May 26, 2020

**Resolution Copper Project**  
**Skunk Camp Tailings Storage Facility**  
**Response to Action Item WR-23: TSF Storage Contingency**  
**Doc. # CCC.03-81600-EX-LTR-00019 – Rev. 0**

**Figure 1 Cycloned Sand Requirements for Scavenger to Pyrite mass ratio of 75%:25% Scenario<sup>1,2</sup>**

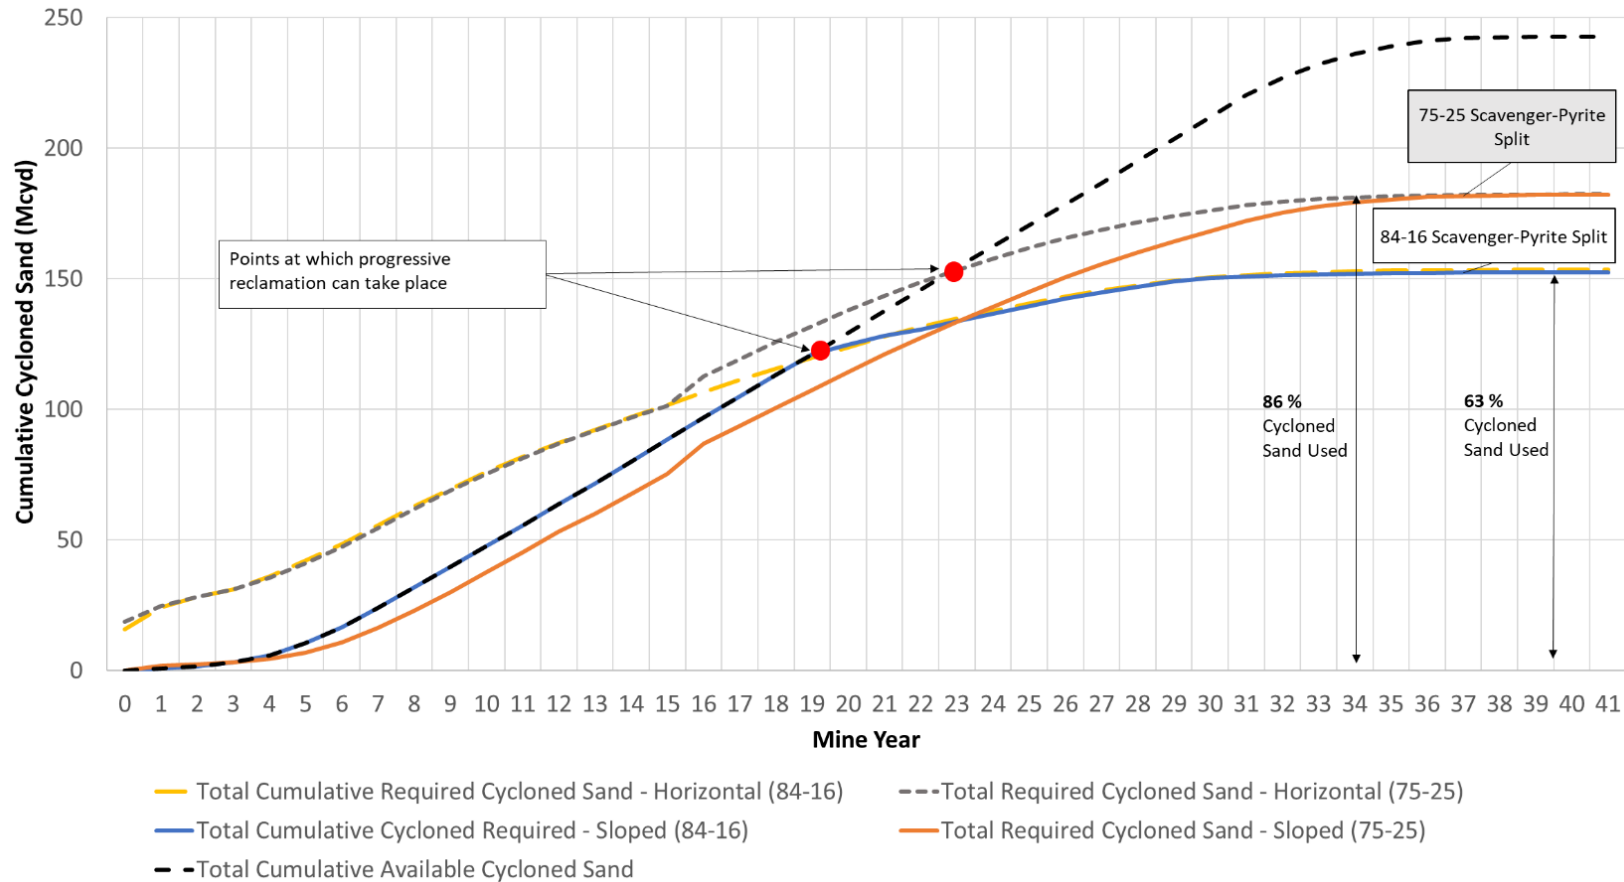
During a working group meeting on March 26, 2020 a question was raised about what contingency is included in the Skunk Camp TSF design to manage variations in the expected mine plan (i.e., split between scavenger tailings and pyrite tailings). An action item (WR-23) was assigned to KCB Consultants Ltd. (KCBCL) to summarize the flexibility/contingency in the TSF design.

- **Scavenger to pyrite mass ratio of 75%:25% (from 84%:16% included in the DEIS):** a mass balance on a less advantageous ratio was completed to assess if it would result in a cycloned sand deficit. It was estimated that 86% of available cycloned sand (by volume) would be required for a scavenger to pyrite ratio of 75:25 (compared to 67% for the 84:16 ratio used for design) (See Figure 1), but there was still adequate cycloned sand to construct the TSF.

- Notes:
1. “Horizontal” refers to embankments being constructed in horizontal raises that extend to the ultimate downstream face. Horizontal construction allows progressive reclamation to take place on the downstream embankment slope.
  2. “Sloped” refers to embankments being constructed using sloped construction, where the downstream slope of the embankment is always maintained. The volume required for this construction methodology represents the minimum amount of cycloned sand that must be placed annually to meet the crest elevation requirement.
  3. Although there is enough cycloned sand for embankment construction, progressive reclamation of the Main Embankment will be delayed in the case where the scavenger-pyrite split is 75-25.
